AMENDMENT TO FACILITY OPERATING LICENSE

Amendment No. 5
License No. DPR-25

CHANGE NO. 22 TO THE TECHNICAL SPECIFICATIONS

SAFETY EVALUATION BY THE OFFICE OF NUCLEAR REACTOR REGULATION
SUPPORTING AMENDMENT NO. 5 TO FACILITY OPERATING LICENSE NO. DPR-25
(CHANGE NO. 22 TO THE TECHNICAL SPECIFICATIONS)

Figure 2.1-2
 PEAK LHGR VERSUS CORE THERMAL POWER
 FOR A LIMITING TOTAL PEAKING FACTOR

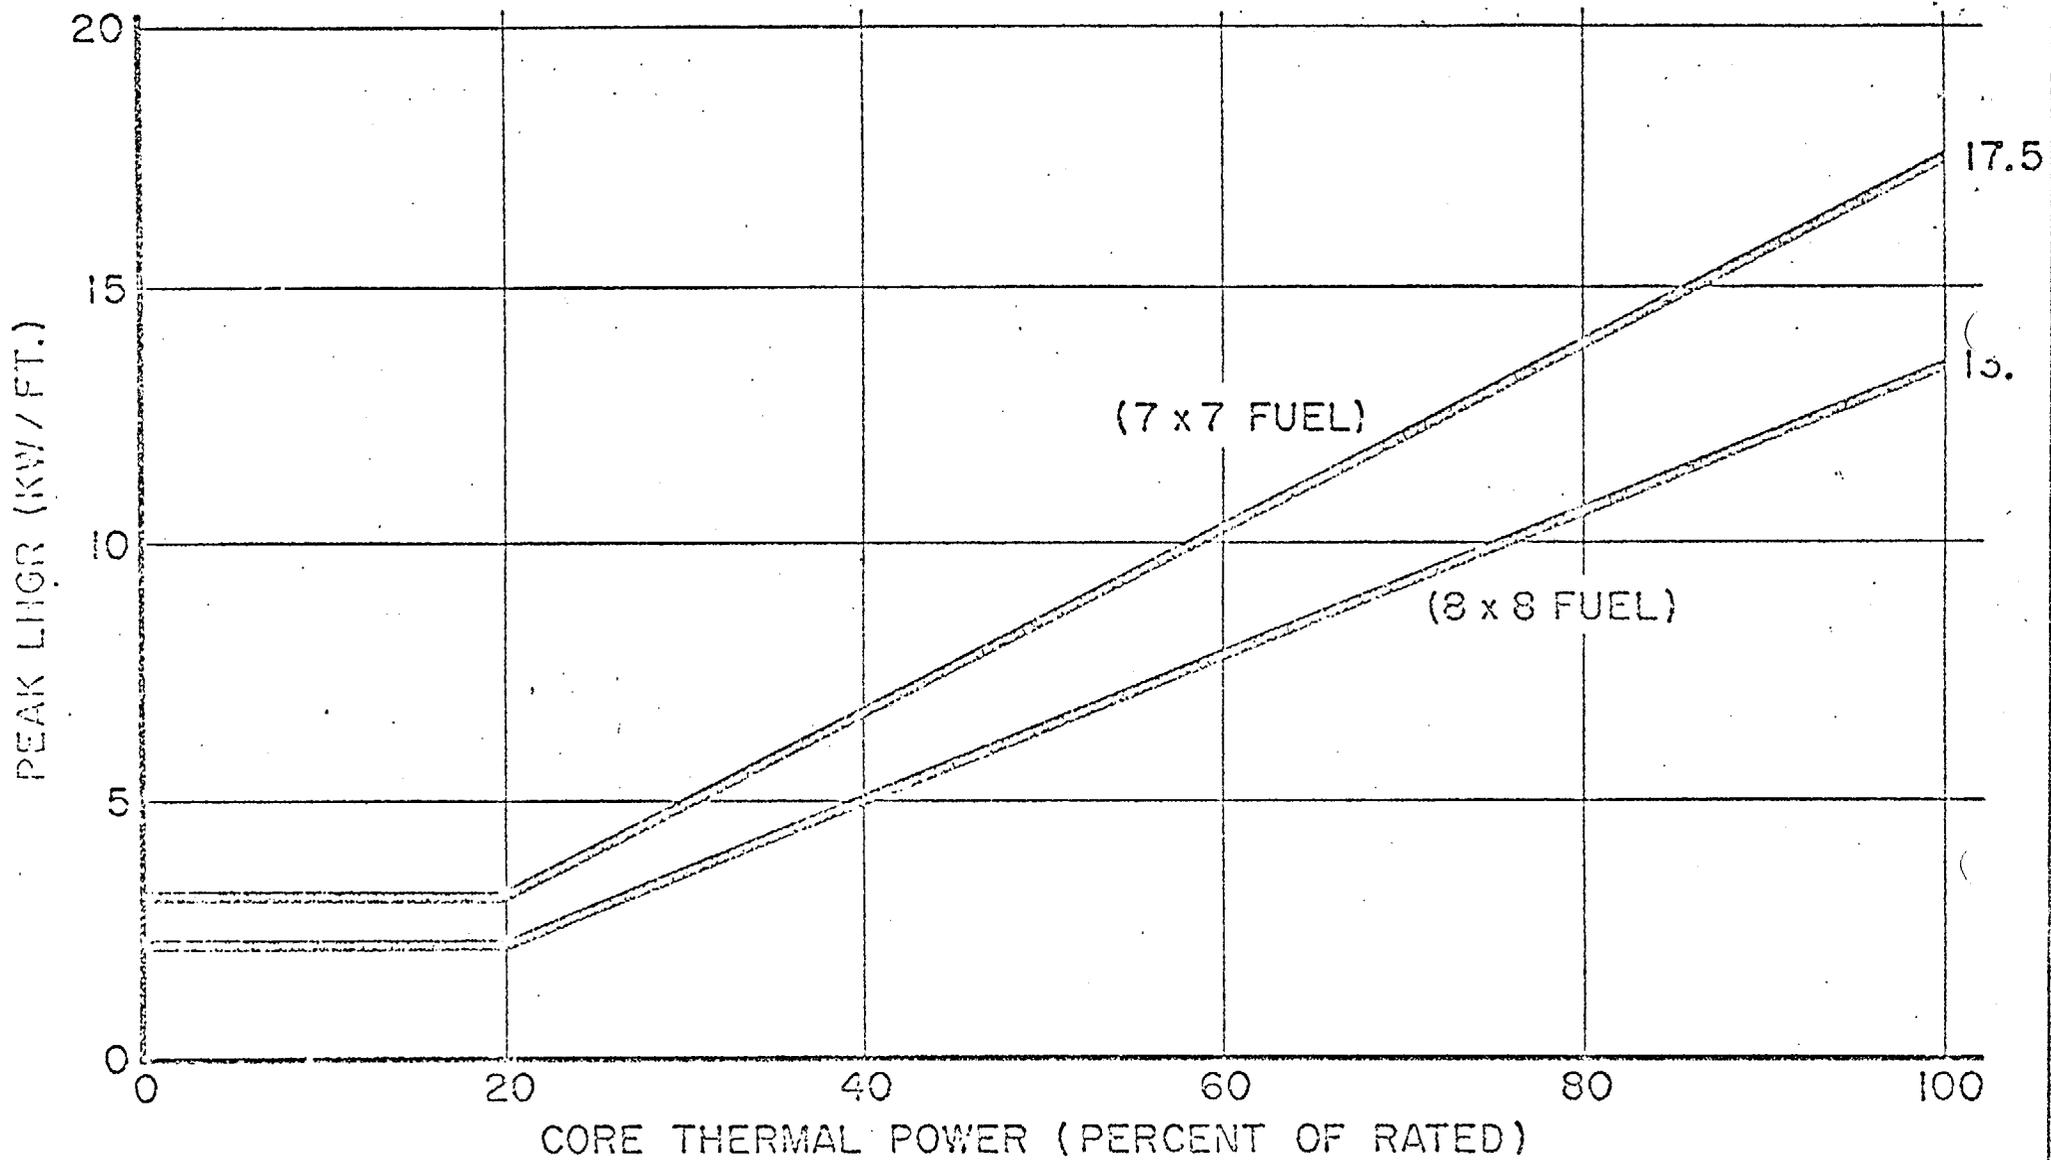
TPF = LTPF unless the combination of power and peak LHGR is above the curve in Figure 2.1-2 at which point the actual peaking factor value shall be used.

Subsections A.1 concerning APRM neutron flux scram settings and subsection B concerning APRM rod block settings would express the settings in terms of the new definitions of peaking factors rather than in terms of heat flux, and base the required settings on the design linear heat generation rates of 17.5 and 13.4 kw/ft for 7 x 7 and 8 x 8 fuel respectively. Figure 2.1.2 would be changed from a plot of peak heat flux versus power to a plot of peak LHGR versus power for 7 x 7 and 8 x 8 fuel. For power levels between zero and 20%

Figure 3.5.1-1

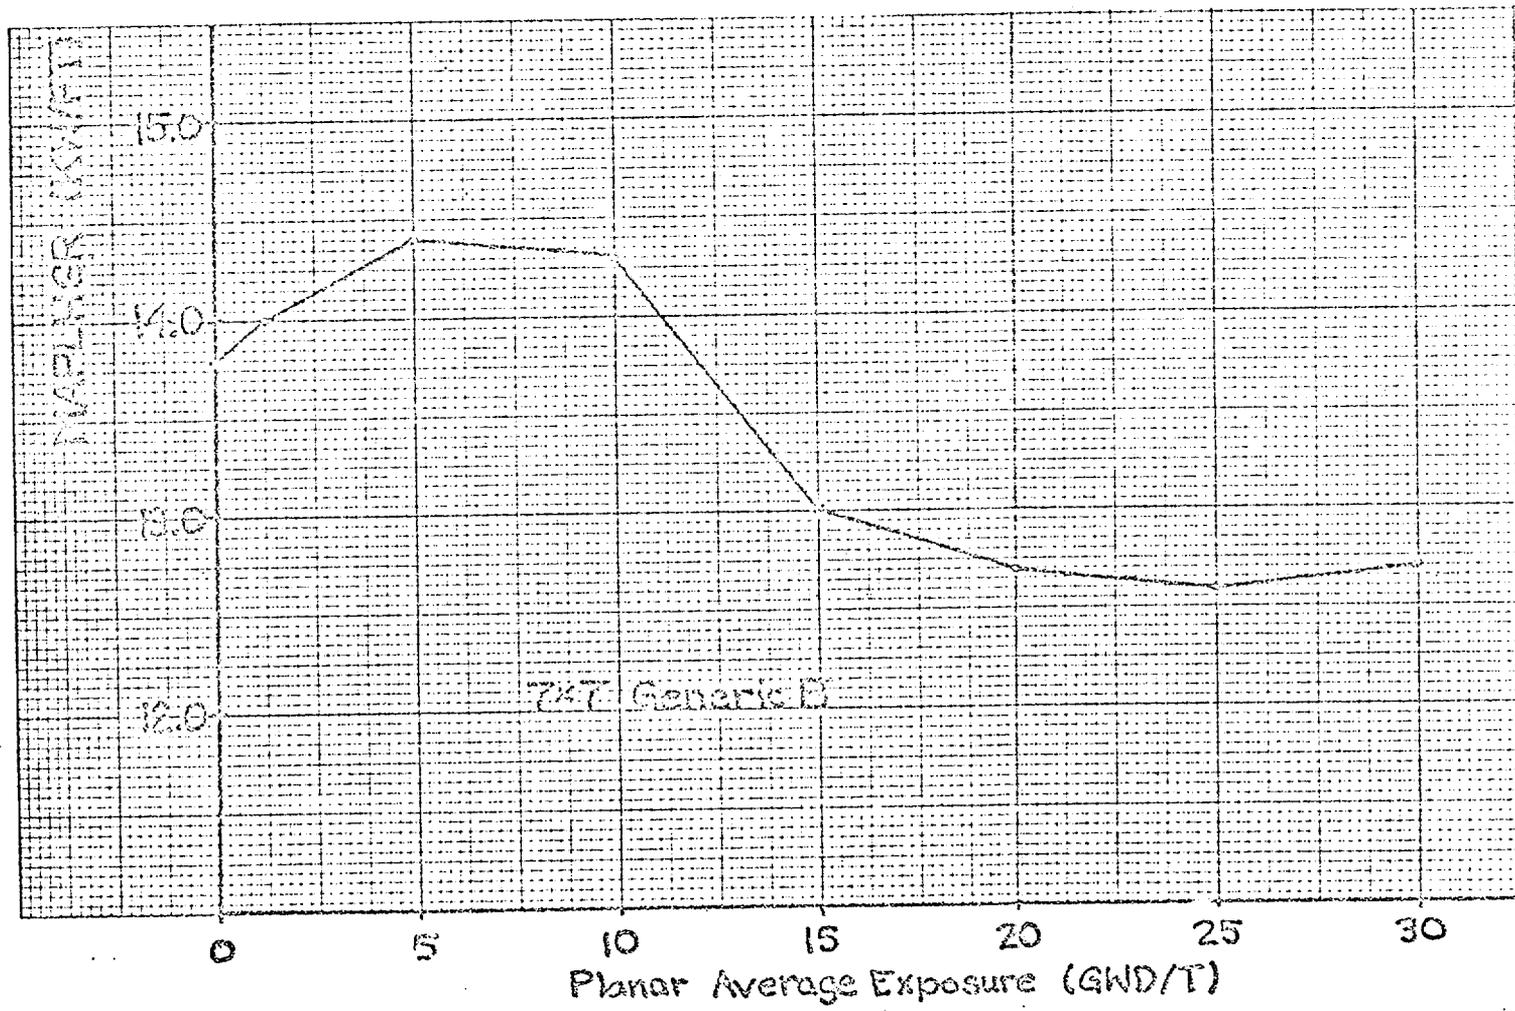
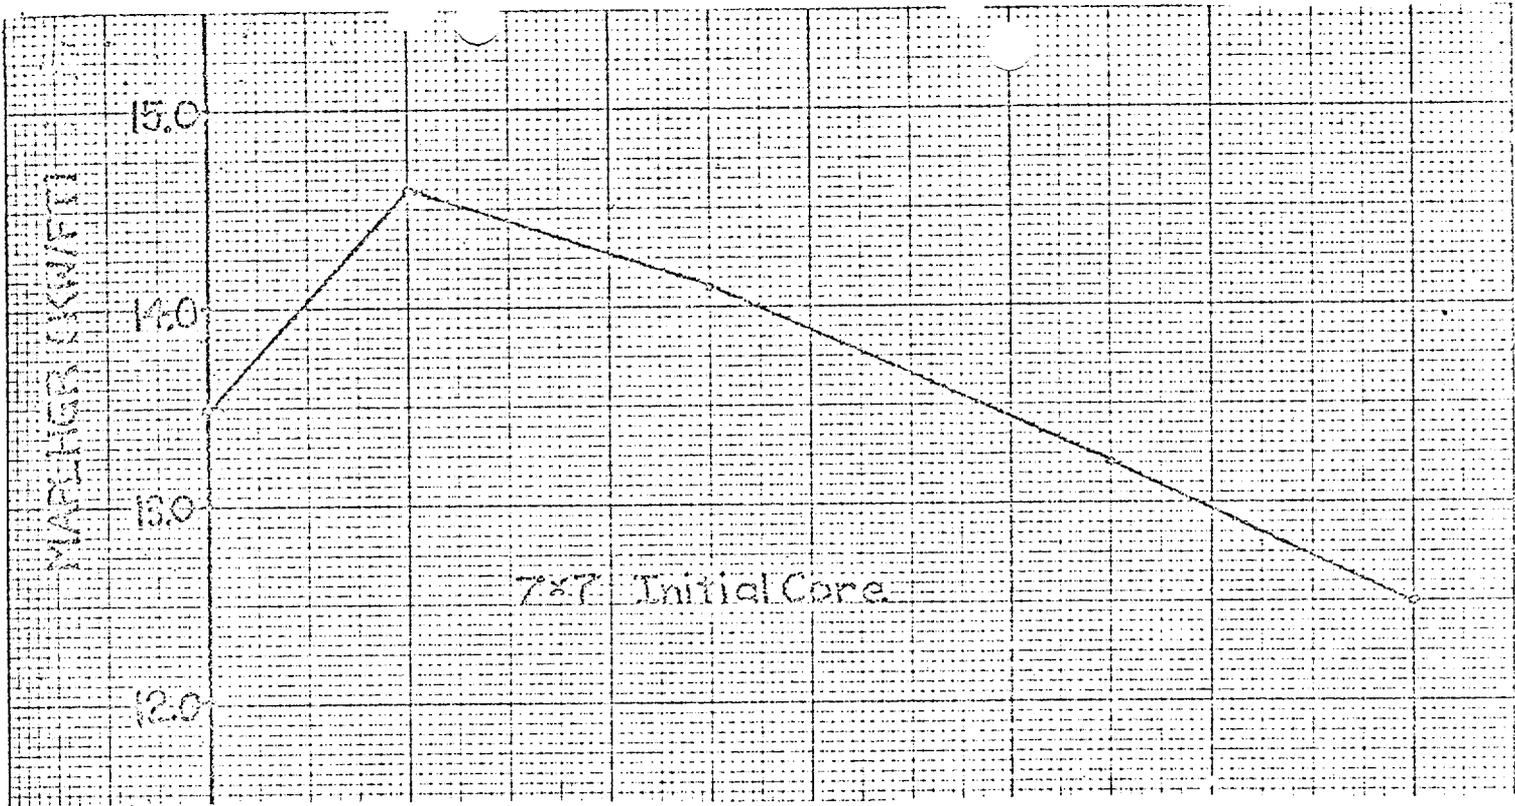
22 During steady state power operation, the average linear heat generation rate (LHGR) of all the rods in any fuel assembly, as a function of average planar exposure, at any axial location, shall not exceed the maximum average planar LHGR shown in Figure 3.5.1.

Section 3.5.I. Average Planar LHGR Limiting Conditions for Operation

The average planar linear heat generation limits would be revised to be consistent with the analyses performed in accordance with 10 CFR 50.46.

FIGURE 3.5-2 K_f FACTOR

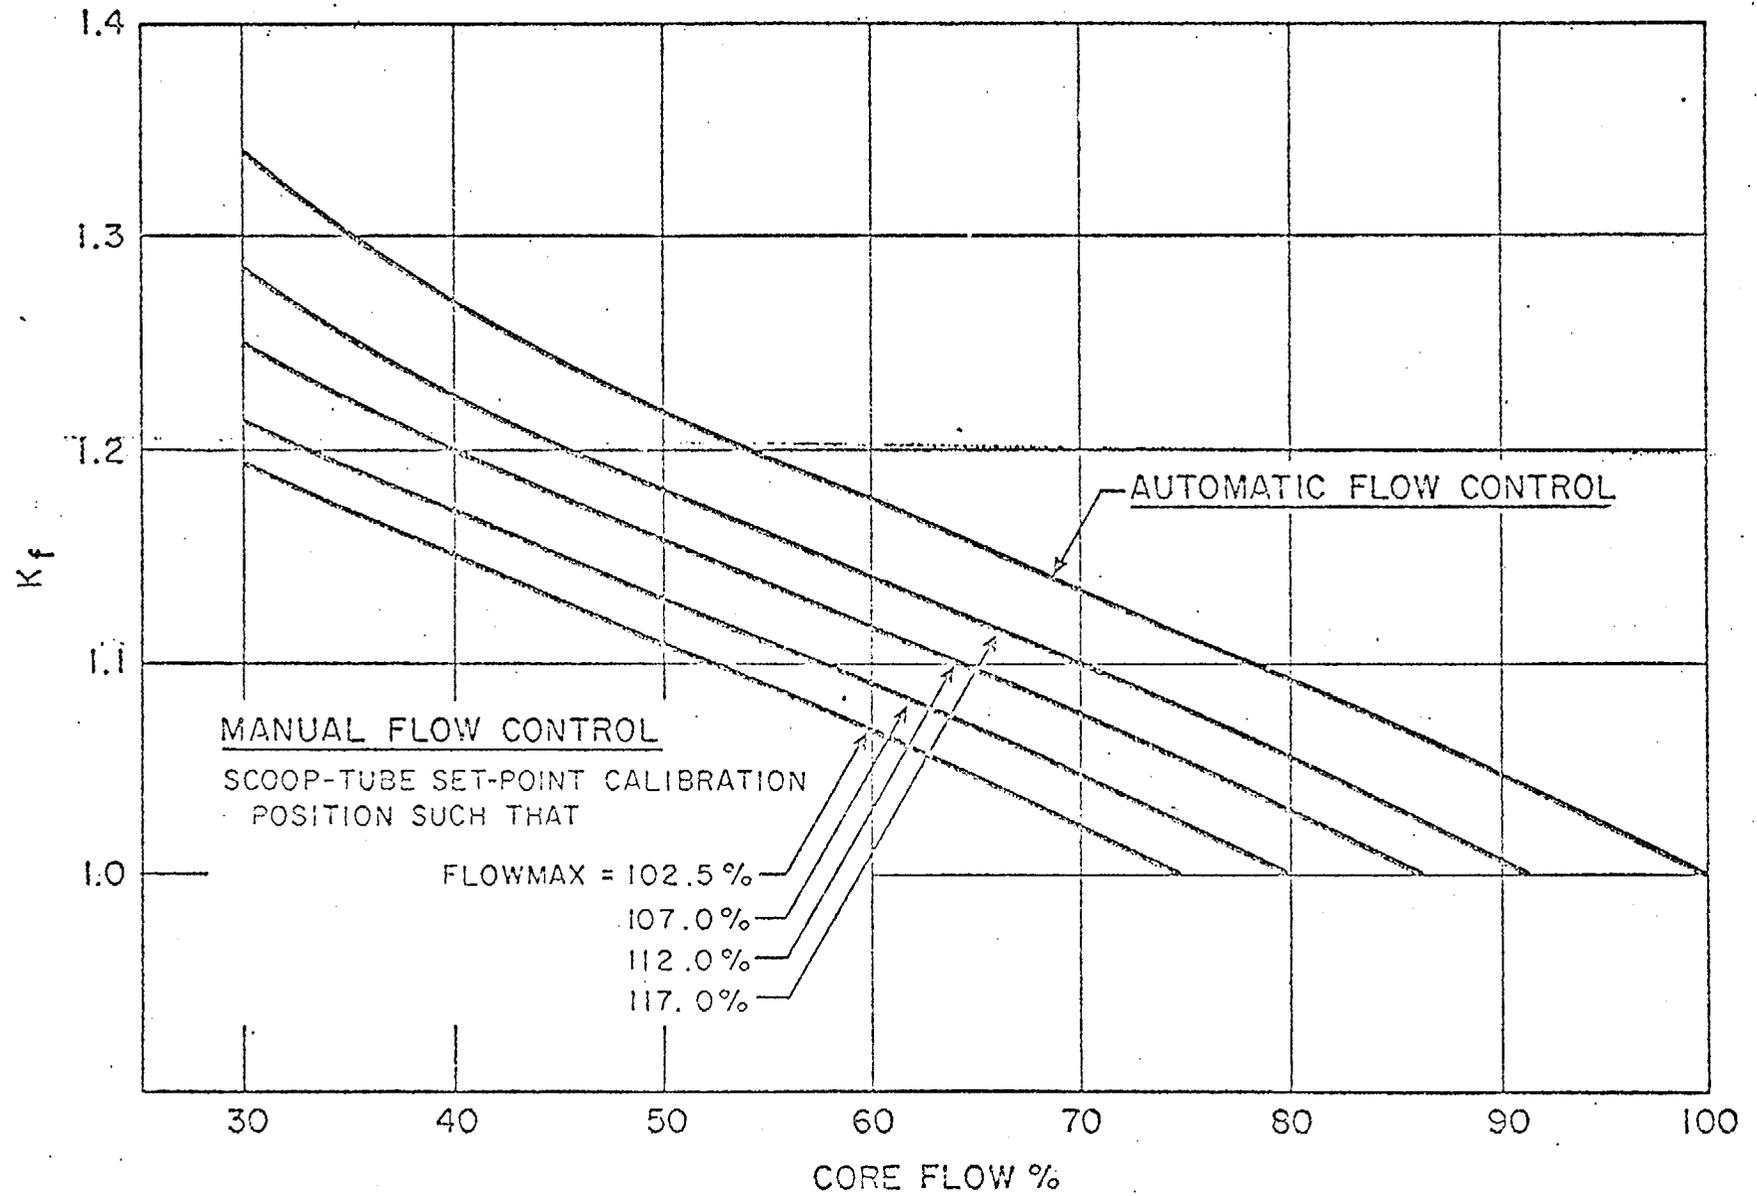
at rated power and flow. For core flows other than rated, these nominal values of MCPR shall be increased by a factor of K_f , where K_f is as shown in Figure 3.5-2.

Subsection 3.5.k. would be added to place operating MCPR limits on 7 x 7 fuel and 8 x 8 fuel. The limits are consistent with the GETAB analyses discussed earlier in this report and require a MCPR more limiting than that needed to satisfy the requirements of the LOCA analysis.
